MODEL
3.5RL
3.2TL

BULLETIN NO.
99-036

Safety Recall: Extension Shaft Sealing Bolt

36 mm Sealing Bolt Set: P/N 90082-PY5-305
(The set includes a new sealing bolt and O-ring.)

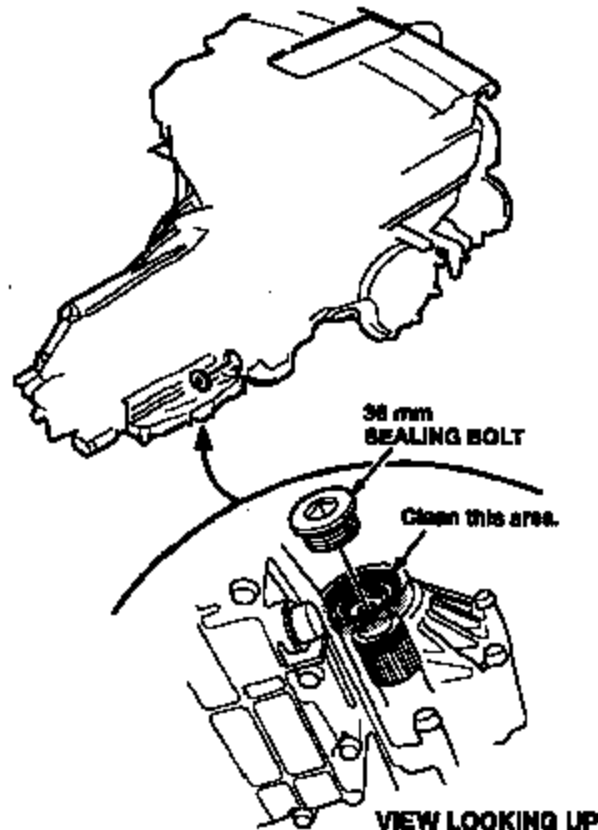
The 36 mm sealing bolt on the side of the transmission housing may loosen and fall out. If this occurs, the extension shaft may back out and disconnect from the differential. If this happens while driving, the car loses power to the drive wheels without warning. If the car is stopped with the transmission in Park and the parking brake not engaged, the car could move unexpectedly.

Replace and properly torque the 36 mm sealing bolt.

3. Remove the 36 mm sealing bolt.
4. Use brake cleaner and compressed air to clean the threads in the transmission housing. Wear eye protection.
5. Install the O-ring on the new sealing bolt.
6. Install the new 36 mm sealing bolt. Do not use any thread lock or thread sealer. Torque the bolt to 78 N-m (58 lb-ft).
7. Lower the vehicle.
8. Center-punch a completion mark above the third character of the engine compartment VIN.
